TOWN OF BAY HARBOR ISLANDS PLANNING AND ZONING BOARD

April 17, 2018

Subject: Site Development Plan Application – Revision #1
Atlantis of Bay Harbor – 28 DU Multi-Family Residential Complex
10281 West Bay Harbor Drive
Bay Harbor Islands Acct. No. MB2017-21
MMPA Acct. No. 01-0702-1049

Below are all of the changes since the PZ Board approved the plans on March 21st, 2017:

DRAWING TITLE:
BACK
ELEVATION
SCALE: 3/32"=1'-0" DATE: APRIL 3, 2018
SHEET NUMBER:
A-2.03
P&Z REVISIONS

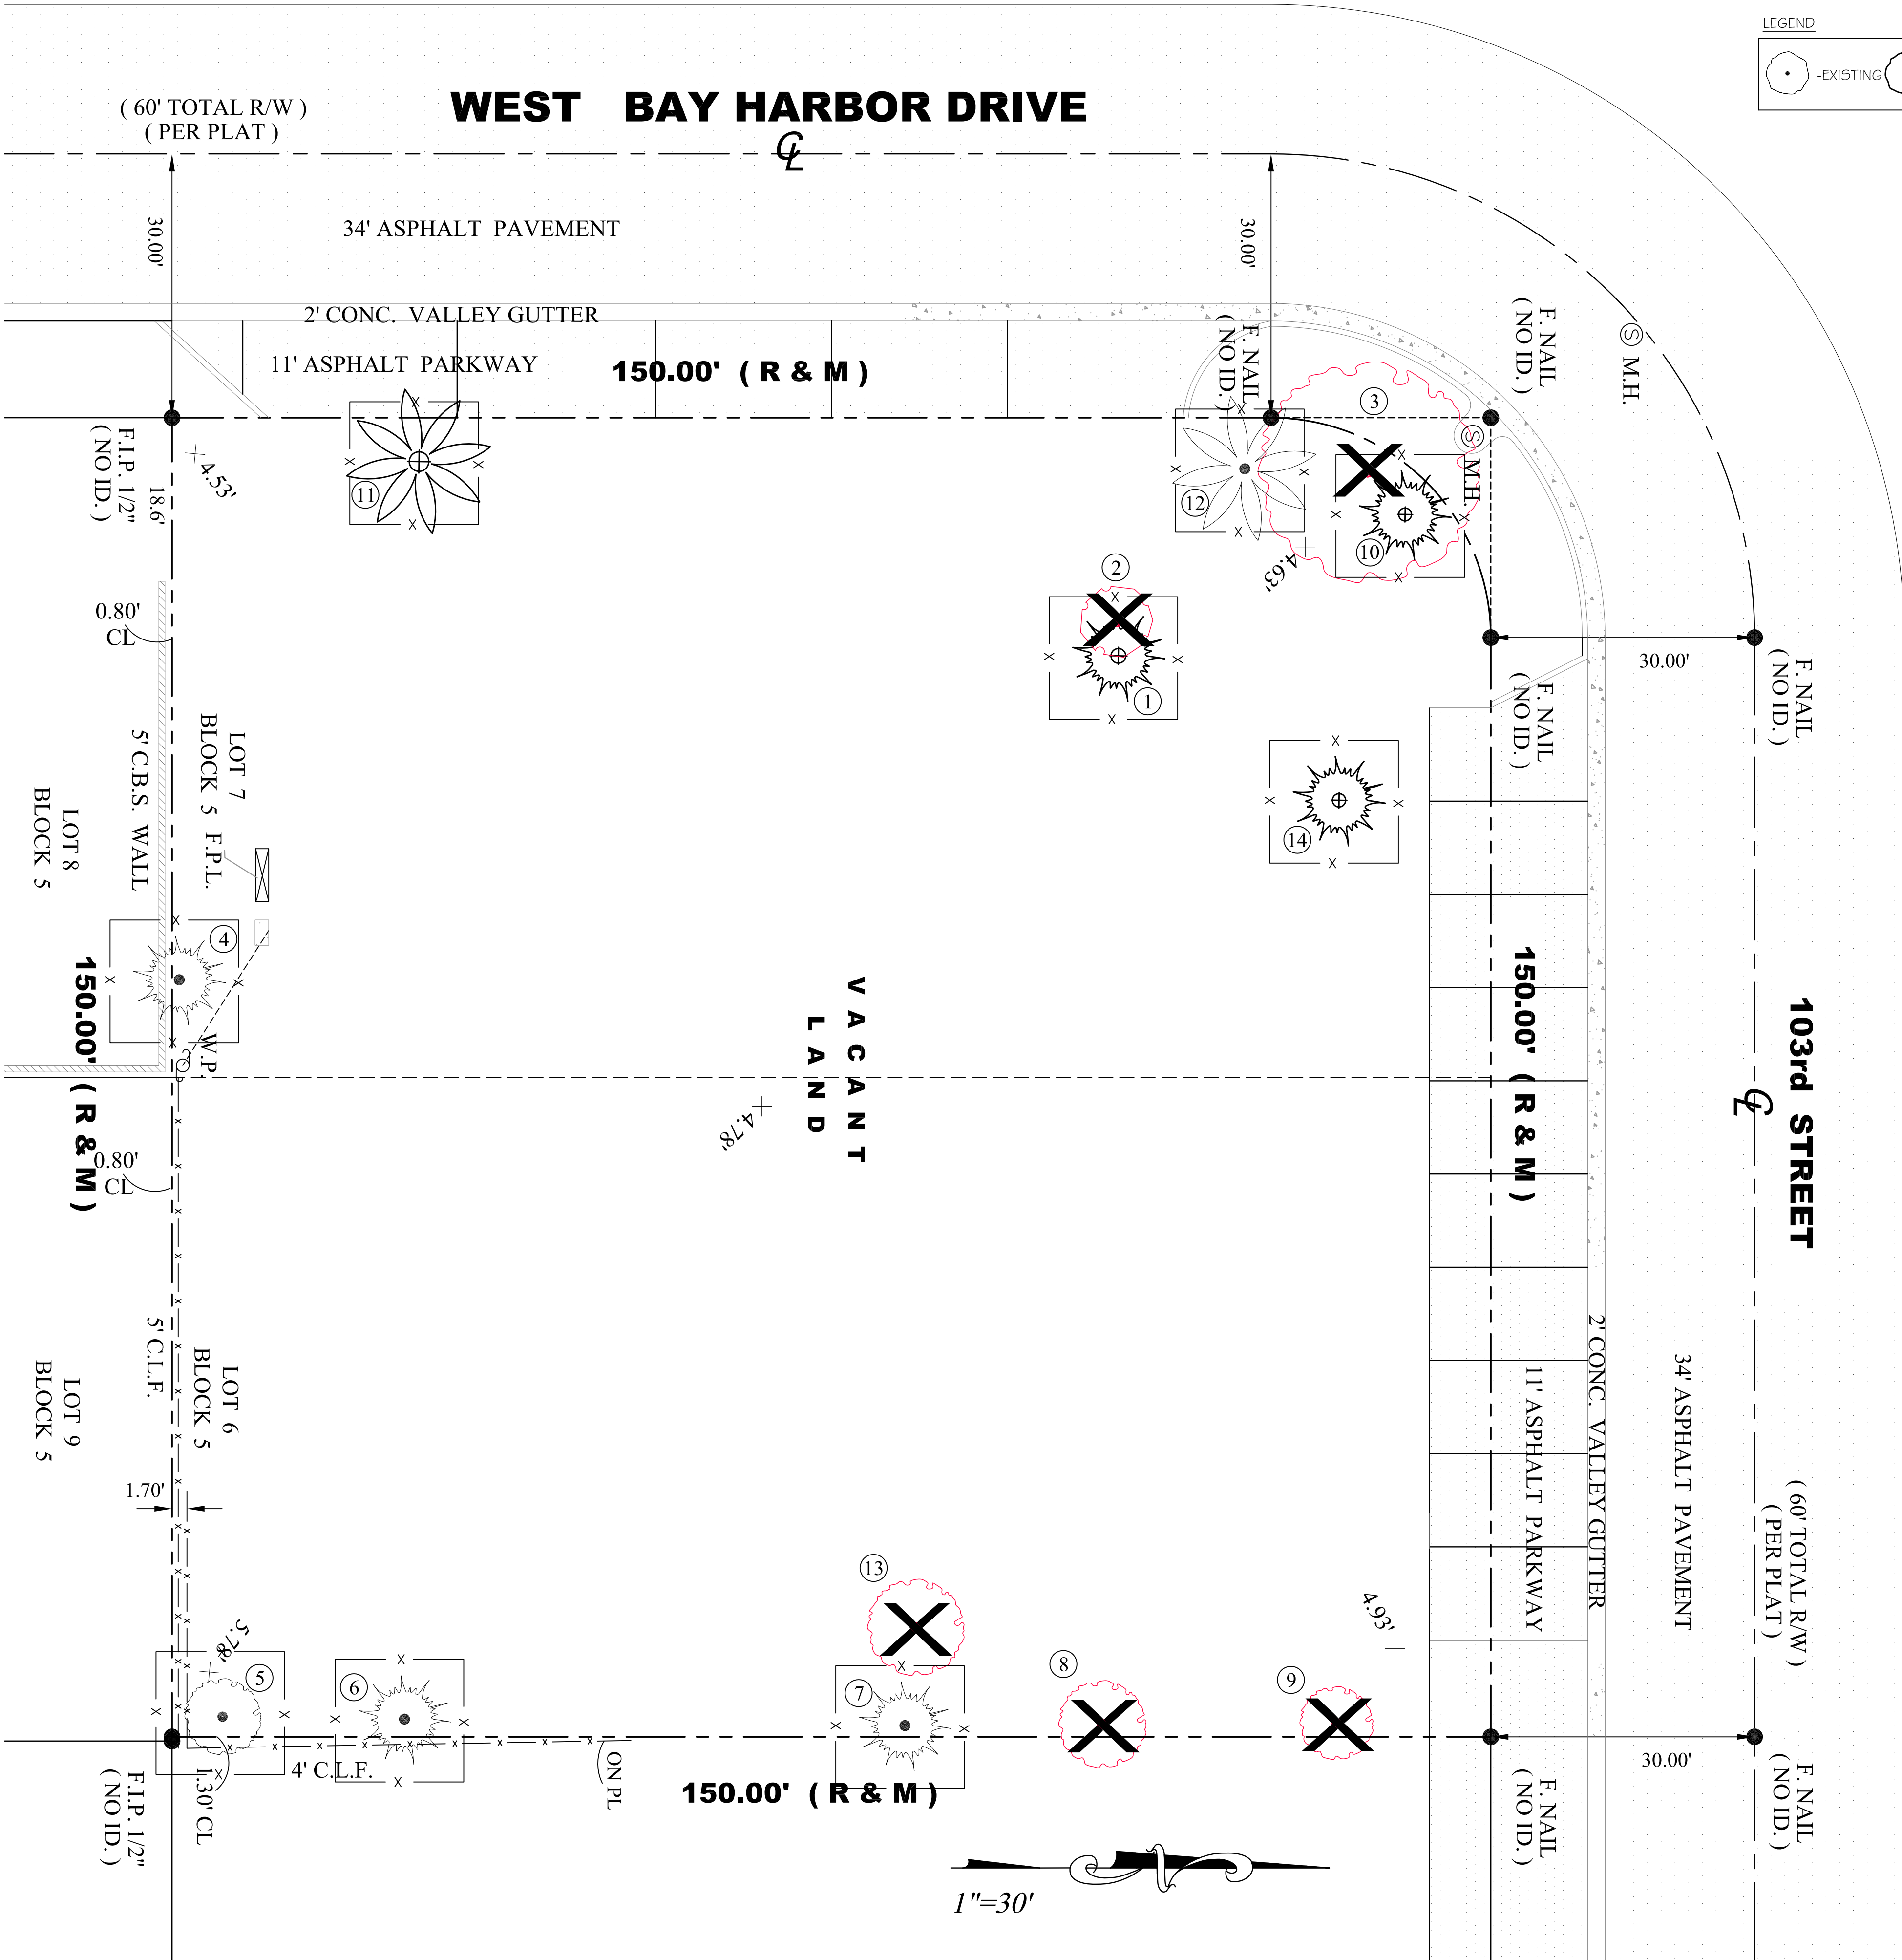
NOTES:
1 REDUCE GLAZING AREA.
